Docket Number:	17-BSTD-02
Project Title:	2019 Title 24, Part 6, Building Energy Efficiency Standards Rulemaking
TN #:	223260
Document Title:	Staff Analysis of Air Filter Pressure Drop and Air Filter Sizing (April 2018)
Description:	Staff Analysis of Air Filter Pressure Drop and Air Filter Sizing (April 2018) *** THIS FILE SUPERCEDES TN# 223245-14*** and corrects an issue where tracked edits to a paragraph were shown.
Filer:	Peter Strait
Organization:	California Energy Commission
Submitter Role:	Commission Staff
Submission Date:	4/23/2018 1:00:37 PM
Docketed Date:	4/23/2018

Staff Supplement to CASE Report #2019-RES-IAQ-F

Subject: Staff Analysis of Air Filter Pressure Drop and Air Filter Sizing (April 2018)

Figure 1. Pressure Drop for 20" X 30" X 1" Depth Air Filters – 3M Label Data

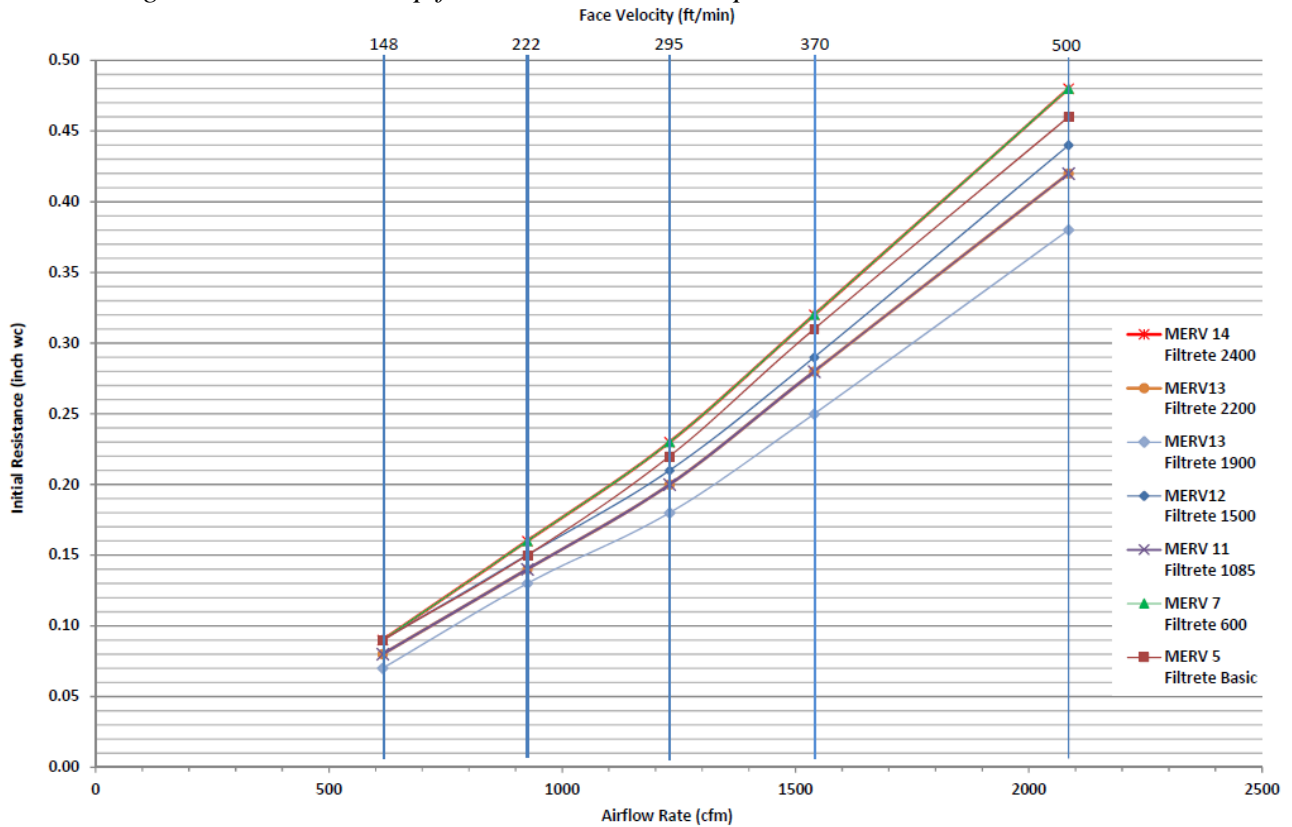
Staff acquired pressure drop performance data from product labels available on 3M brand air filters offered for sale at local home improvement supply stores. The labels on these 3M filters conform to the proposed Title 20 air filter label format. Labeled pressure drop performance data for 1" MERV 5, 7, 11, 12, 13 (two MERV 13 models), and 14 are plotted in Figure 1 below. The

data indicate there is no significant correlation between MERV rating and pressure drop for these models. Note the highest pressure drop performance in this dataset is shared by MERV 7/MERV 14, the second highest pressure drop is for MERV 5, and the lowest pressure drops correspond to the MERV 13 models. Thus, the often-heard concern that MERV 13 filters would cause higher pressure drop in space conditioning systems does not apply to this 3M filter model lineup. Staff's understanding is that 3M air filter products represent a major share of California air filter sales.

Figure 2. 3M Manufacturer Pressure Drop Label Data Compared to Laboratory Measurements

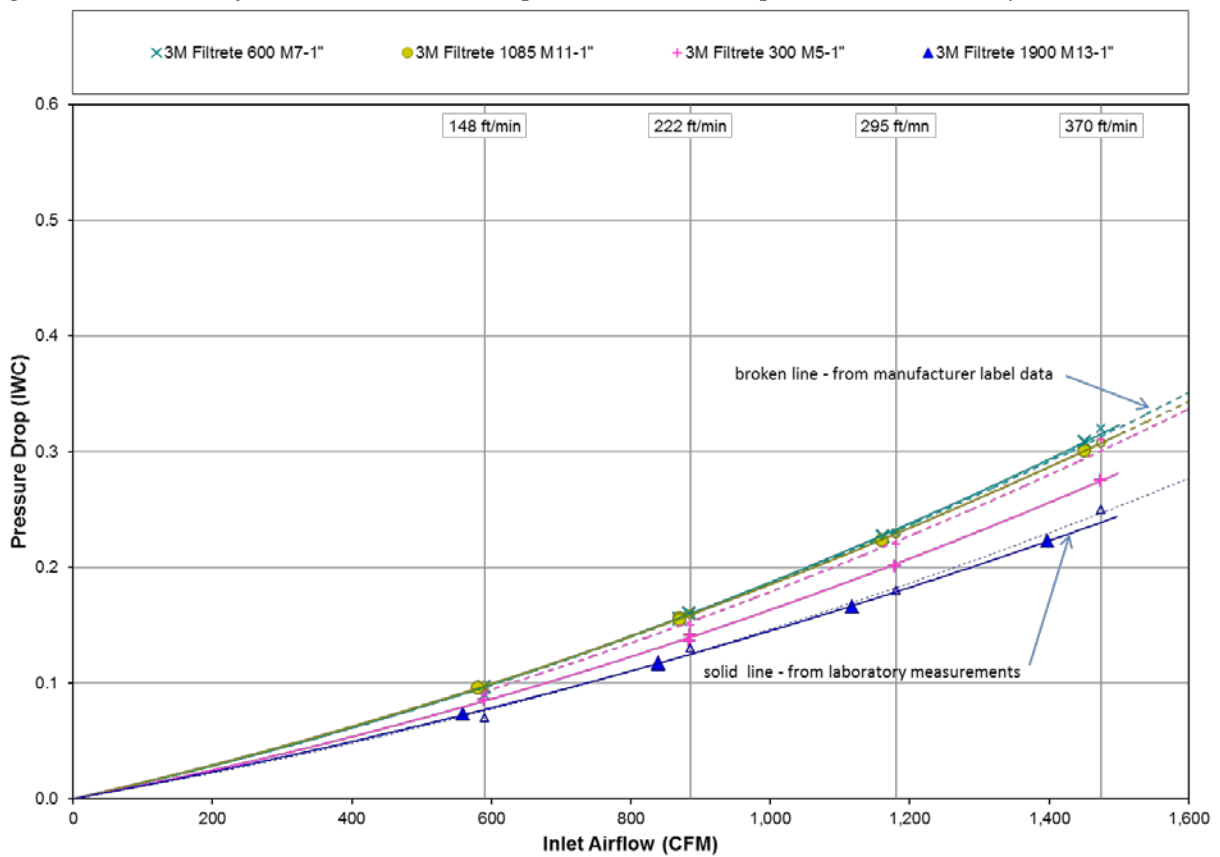
Figure 2 compares the 3M manufacturer's filter pressure drop data measured in the ATS laboratory with the pressure drop performance data from their product labels also plotted to facilitate comparisons. The manufacturer's label data is plotted with either a dashed or dotted line along with the performance data measured in the laboratory which is shown as a solid line. The tested pressure drop corresponded closely to the manufacturer's label data generally, and where the measured data diverges slightly from the published label data, the actual measured pressure drop is less than the published performance values, thus the actual performance was equal or better than published pressure drop and airflow specifications.

- The 3M filter label pressure drop information corresponded very closely to the actual clean filter performance (see Figure 2).
- The pressure drop characteristics of these air filters varied widely, and there is no significant or useful correlation between MERV rating and pressure drop for the observed filter models, which ranged from MERV 6 to MERV 13.

Figure 3. Pressure Drop Measurements – MERV 6, 7, 11, 13 Filters with 24" x 24" Face Area

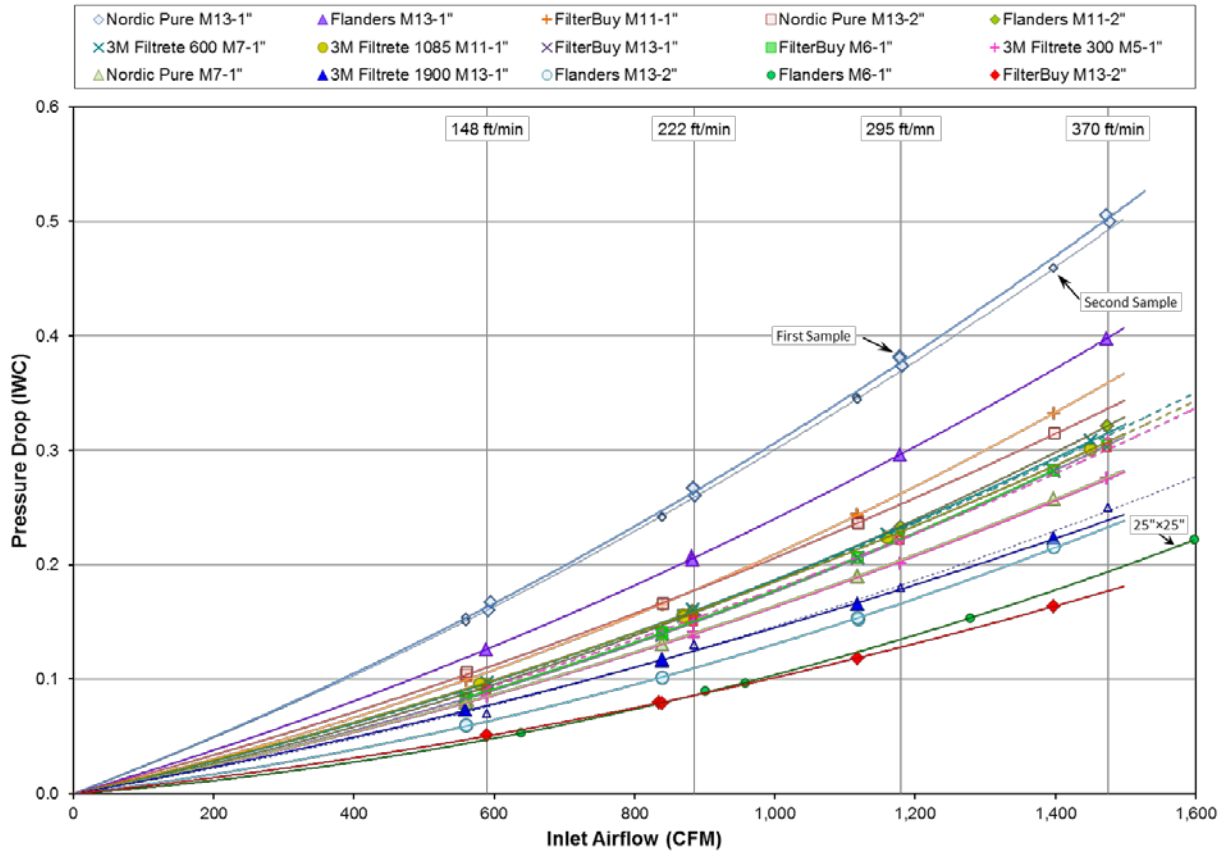
Figure 3 displays measured pressure drop for all fifteen filters tested in the ATS laboratory. Filter particle removal efficiencies in the test set included filters rated at MERV 6, 7, 11, and 13. Four of the filters were 2" depth, and the other 11 filters were 1" depth. The data indicates that there is no significant useful correlation between MERV rating and pressure drop for these models, consistent with the consideration of filter labels in Figure 1.

Figure 4. Pressure Drop Measurements – MERV 13 filters with 24" x 24" Face Area

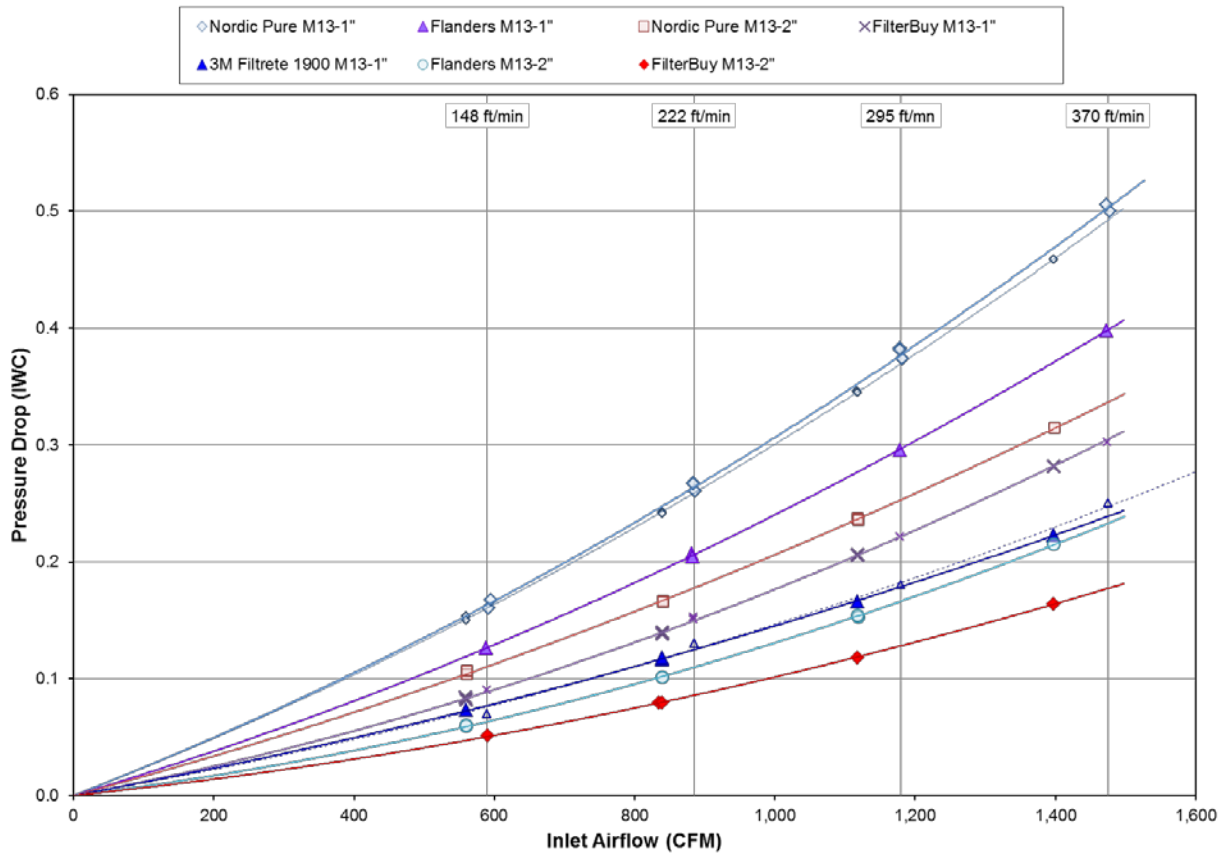
Figure 4 shows the subset of the tested filters that have a MERV 13 rating. Three of the filters are 2" depth, and the other four filters are 1" depth. Four of the filters have pressure drop less than 0.1 inch w.c. at 150 ft/min. 2" depth filters in this data set generally have lower pressure drop as compared to 1" depth filters. The filter with the highest pressure drop had measured airflow less than 400 cfm at 0.1 inch w.c. static pressure. The filter with the lowest pressure drop had measured airflow of approx. 1,000 cfm at the same 0.1 inch w.c. static pressure. This emphasizes the importance of air filter labeling since all of the 24" X 24" filters in this dataset could be installed in the same 24" X 24" filter grille in a system, but only one of these filters could meet a system requirement for approx. 1,000 cfm at 0.1 inch w.c. pressure drop.

- Three 2” depth MERV 13 filters were tested, and two of those had the lowest pressure drop performance over all others in the dataset, thus indicating that 2” depth filters are readily available that provide improved pressure drop performance compared to 1” depth filters. The best performing 2” depth filter provided approximately 30% greater airflow at 0.1 inch w.c. as compared to the best performing 1” depth MERV 13 filter at 0.1 inch w.c. in this dataset.

- MERV 13 rated models with clean filter pressure drop performance below 0.1 inch w.c. at 150 ft/min are readily available from multiple manufacturers.
